001_Title Page

001_Title Page

Document Number:
PCB P/N:

Rev
005

Title
020_OP2_Reset_Clock_PCIE

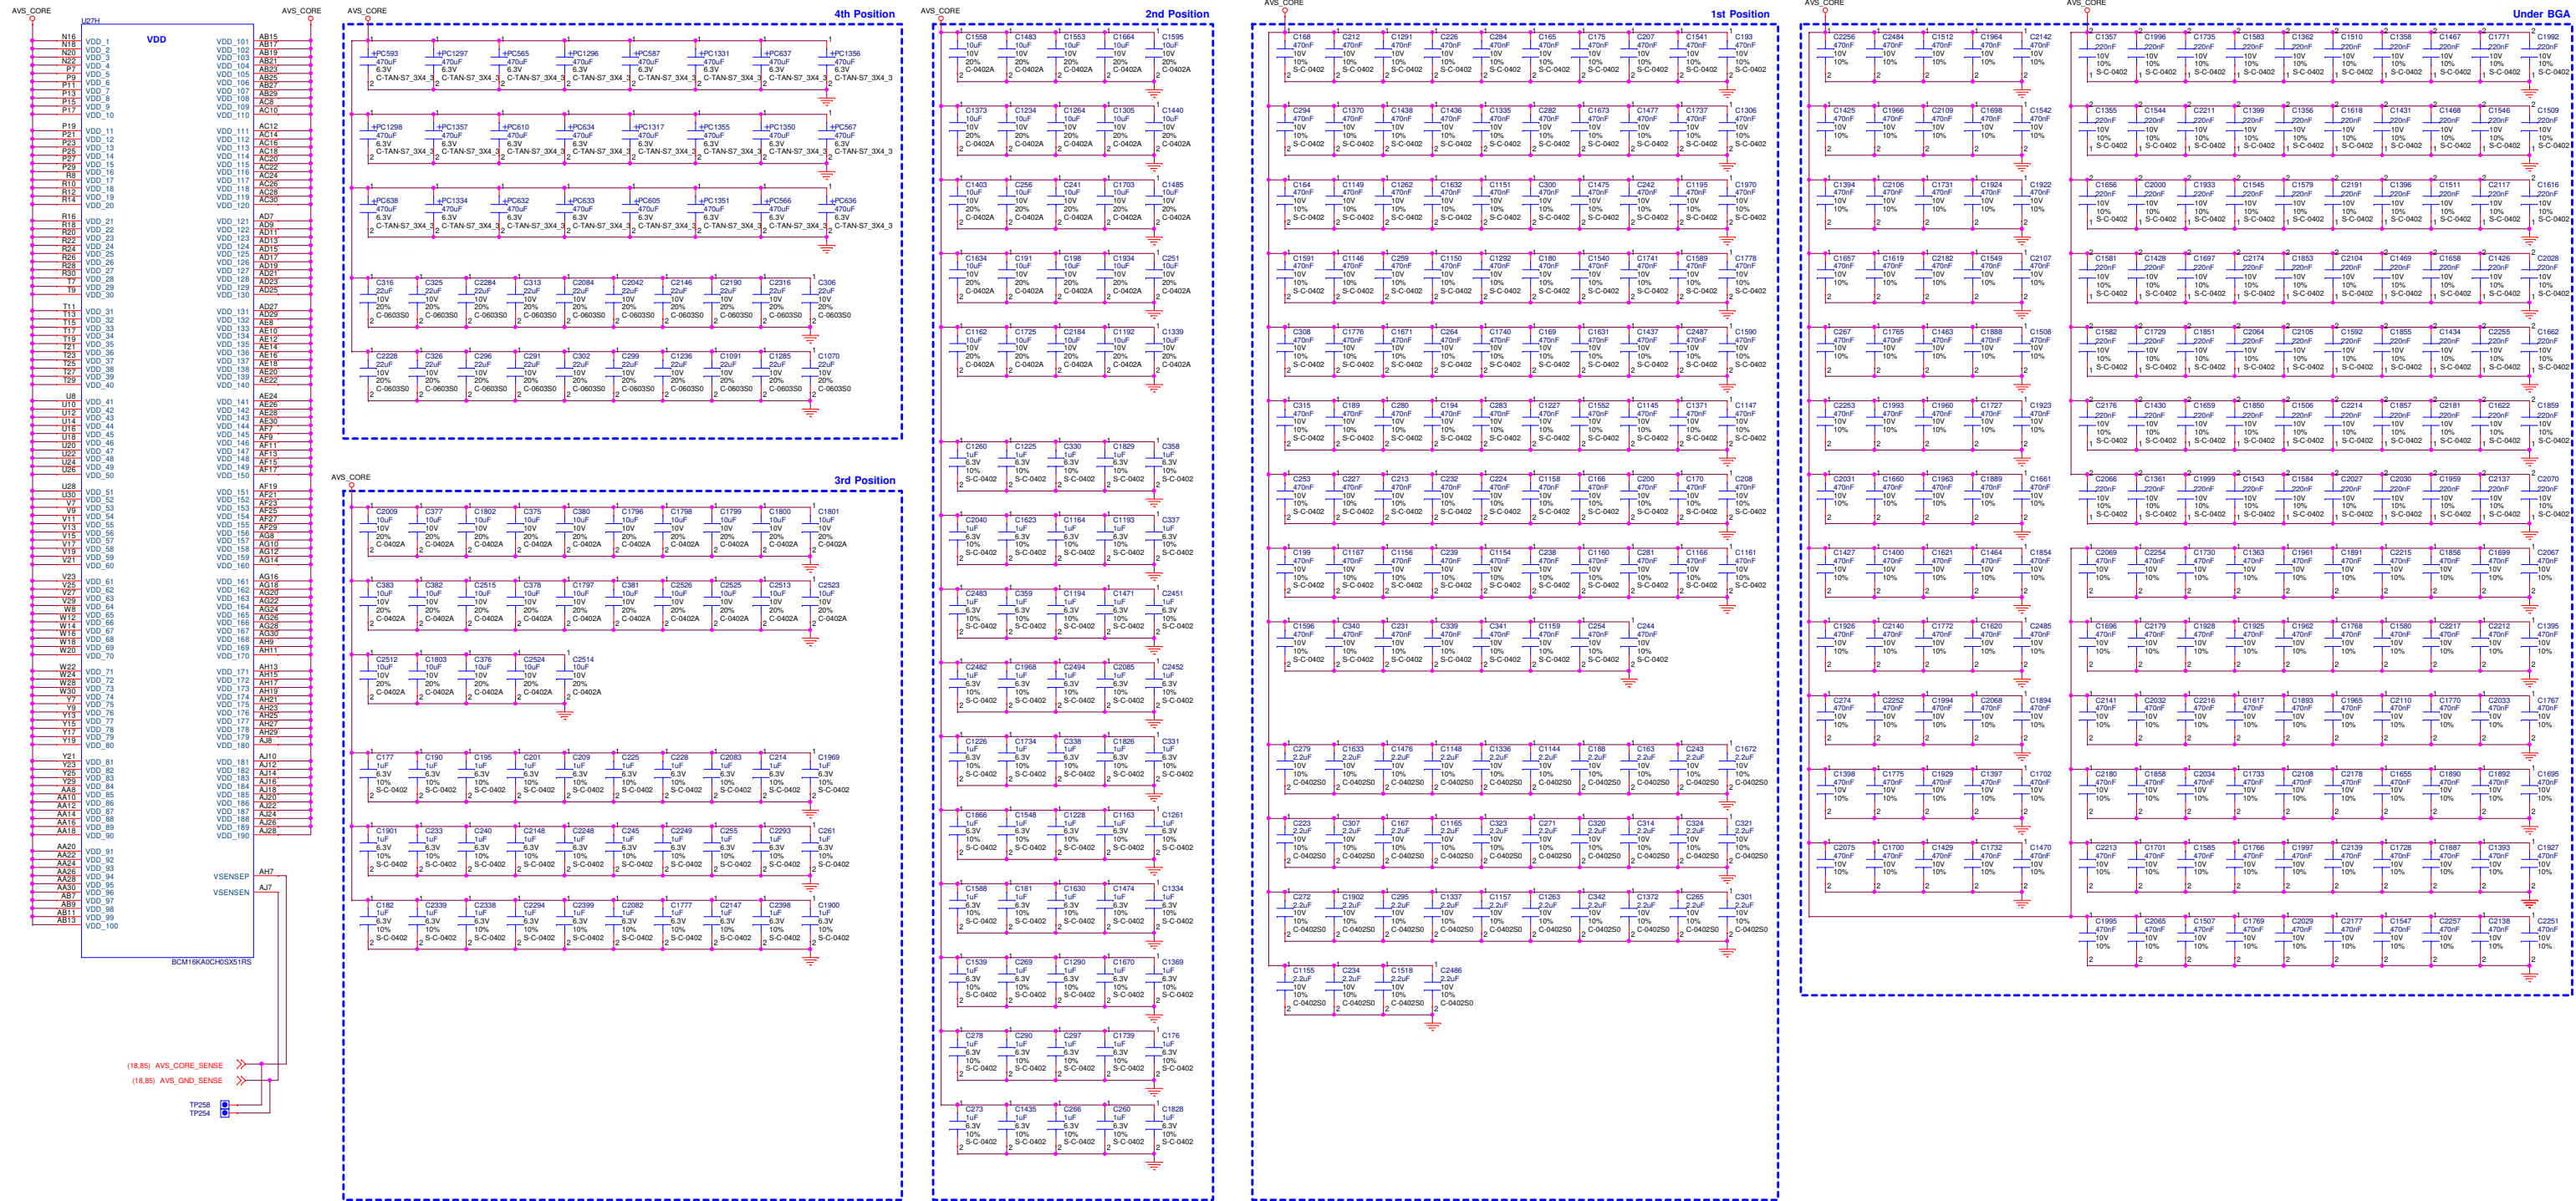
20180904
Change the part from
251.00656.035 to 261.00840.035

20180904
Change the part from
251.00656.035 to 261.00840.035

20180904
Change the part from
032.00037.005 to 032.00034.005

20180904
Add GND test point to RMS Jitter measure

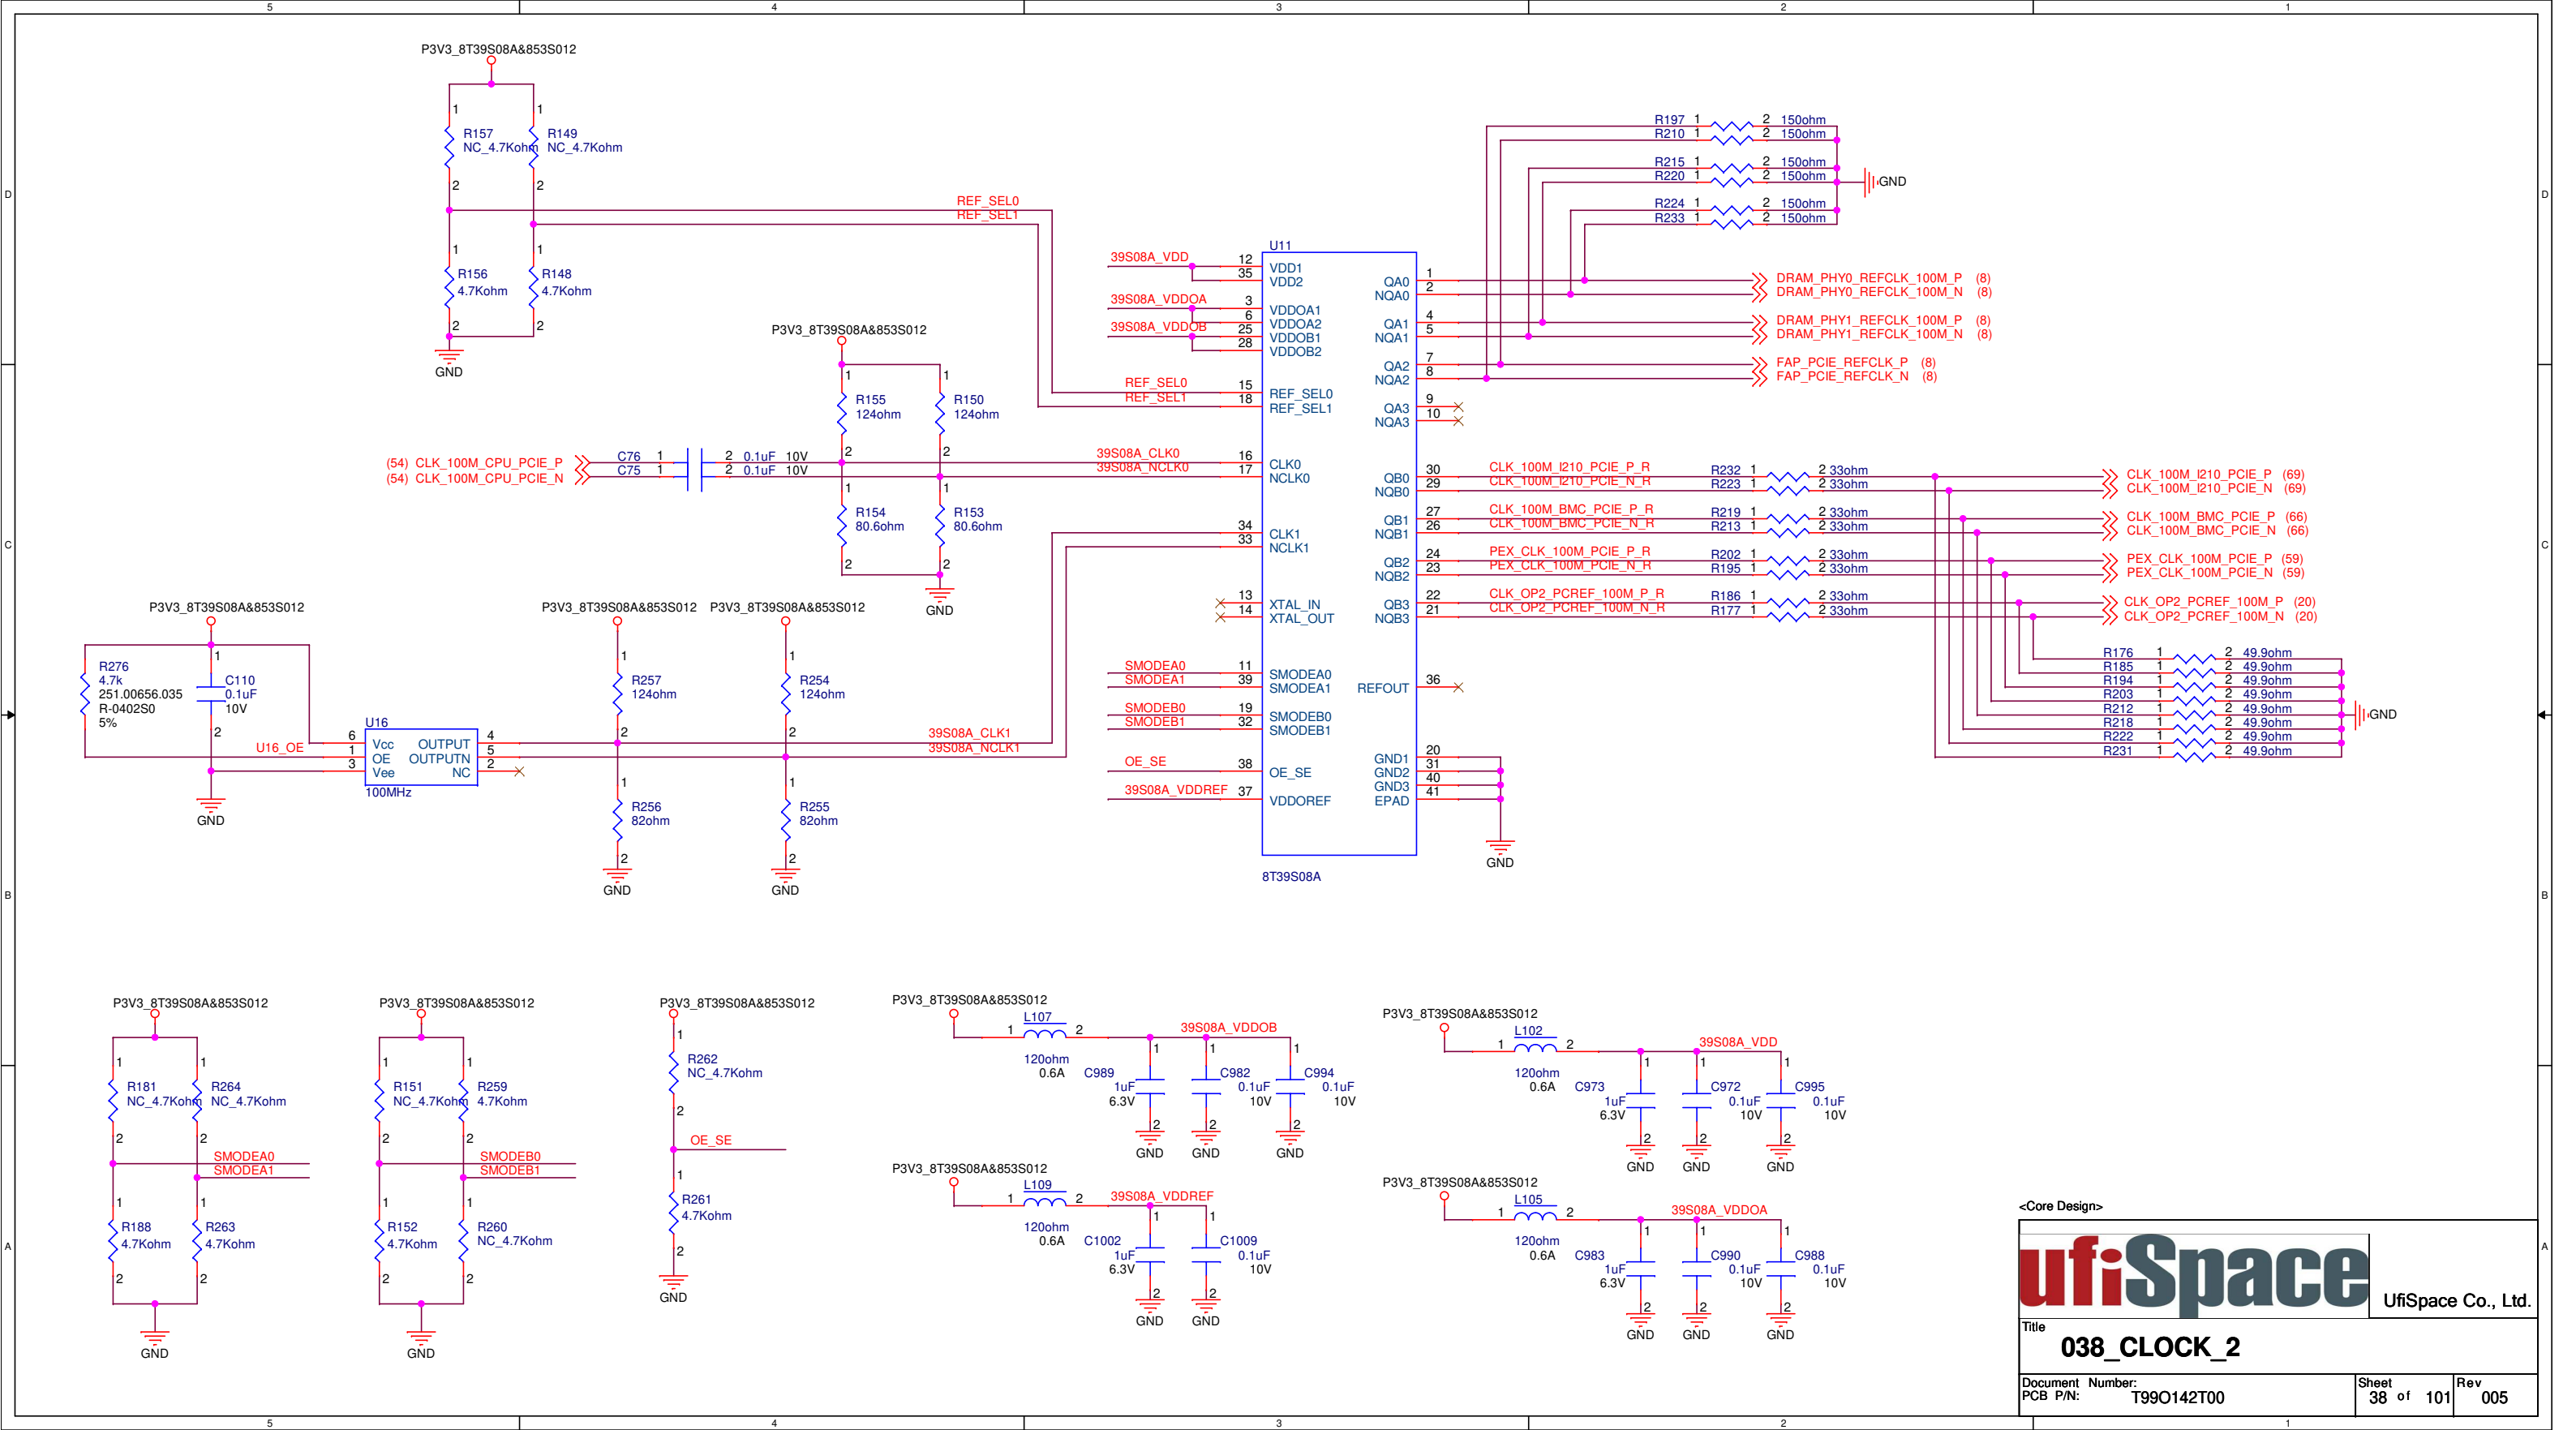
20180912
Remove 8SLVP1204ANLG18 (location U15)
FAB_LCPLL1_P/N connect to U13.J1 & U13.J2 pin
FAB_LCPLL0_P/N connect to U13.H1 & U13.H2 pin
NIF_LCPLL0_P/N connect to U13.A1 & U13.A2 pin
NIF_LCPLL1_P/N connect to U13.B1 & U13.B2 pin
CS4227_P/N connect to U13.E1 & U13.E2 pin

20180911
Remove PU1
